RESEARCH AND ENGINEERING, INC.

Re: Discussion of the Mitigation and Sediment Dynamics associated with Siasconset Beach Preservation Fund, Notice of Intent Application for Expanded Baxter Road and Sconset Bluff Storm Damage Prevention Project

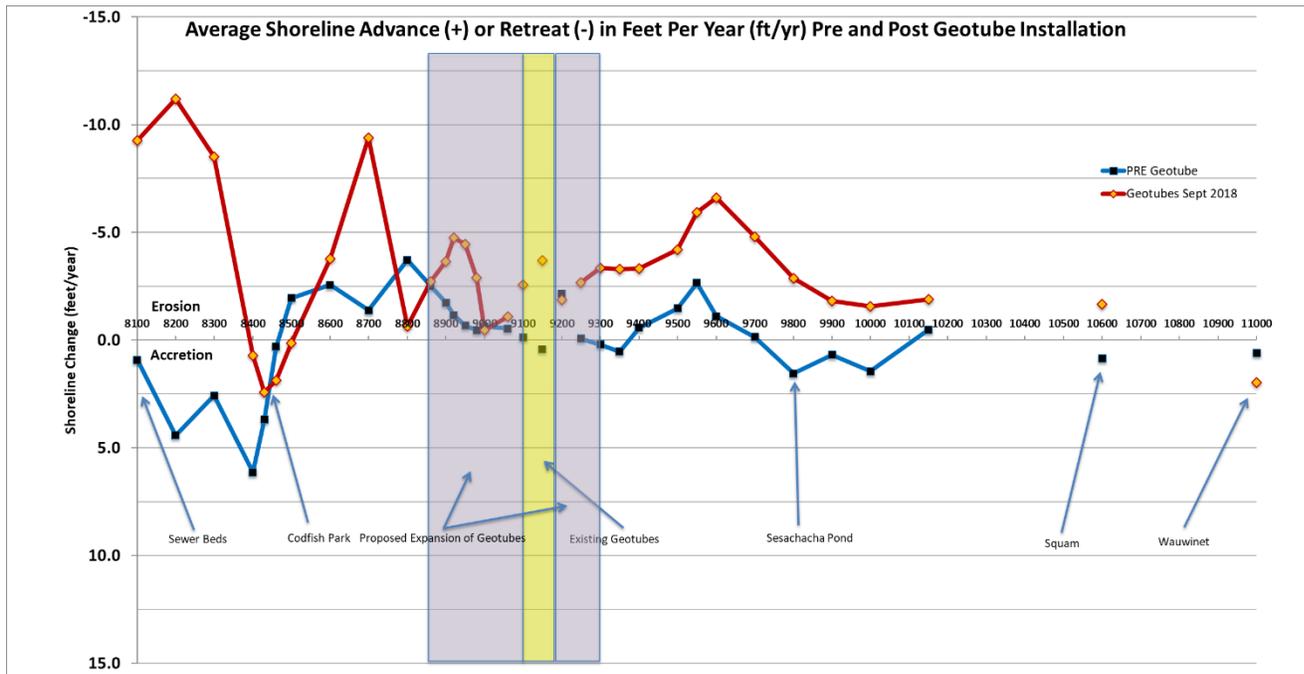
Profile 90. Erosion rates across the entire proposed project reach have increased since the geotextile revetment was constructed. Plotting the rate of shoreline change across all of the long-term monitoring profiles provided in SBPF's monitoring reports and comparing the time period before the installation of the revetment with the time period post construction shows a significant increase in erosion across the entire project area and a majority of the monitored coastline. The increased rate of erosion is illustrated in Figure 1. The period pre-geotube is represented by the blue line and the period post-geotube is represented by the red-line. The rate of erosional shoreline change has increased along the entirety of the monitored shoreline since the geotextile revetment was installed 5-years ago. The exception is the shoreline at Codfish Park which was accretional during both time periods. To the north of the project, erosion rates are consistently higher after the geotextile revetment was constructed. South of the project, the rate of change is not consistent, though it has increased along a significant portion of the coastline. The increase in erosion north and south of the existing geotextile revetment, also suggests that at the present mitigation volume of 22 cy/lf/yr there is not oversupplying sediment to the system as SBPF has suggested. Instead, it suggests that the mitigation volume is possibly significantly lower than the natural bank contribution rate, leading to adverse increase in erosion along adjoining shorelines.
